Address:	21 Grafton St., Chevy Chase	Meeting Date:	9/9/2020
Resource:	Contributing Resource Chevy Chase Village Historic District	Report Date:	9/2/2020
Applicant:	Duane and Paula Gibson	Public Notice:	8/26/2020
<b>Review:</b>	HAWP	Tax Credit:	No
Case Number:	35/13-20BB	Staff:	Dan Bruechert
PROPOSAL:	Walkway replacement, retaining wall installation (retroactive) and fence installation

#### MONTGOMERY COUNTY HISTORIC PRESERVATION COMMISSION STAFF REPORT

# Wall # 1

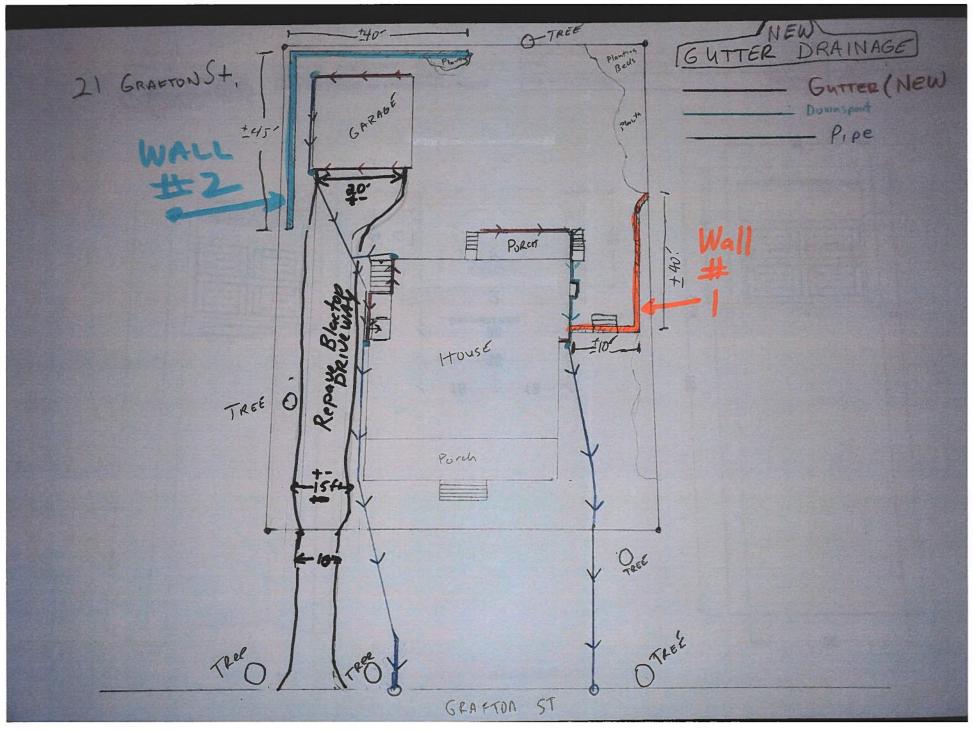
The applicant seeks approval for two retaining walls that have been constructed on the site. The retaining walls are construed out of parged concrete and have a 2" (two-inch) thick capstone. One retaining wall is constructed in the northwest corner of the lot behind the newly constructed garage. The second retaining wall is to the east of the house. Both retaining walls were built to address changes in grade on-site and to better manage water runoff. All retroactive work is to be evaluated as if the work had not been undertaken.

Staff finds in both cases the retaining walls will not have a significant visual impact on the historic resource or surrounding district. Because of the change in grade on the site, rising from the street, then sloping down to the rear, the walls will not be visible from the public right-of-way and should be subject to very lenient review per the *Design Guidelines*. Staff recommends the HPC approve the two retaining walls under 24A-8(b)(1) and (d), Standard 2, and the *Design Guidelines*.
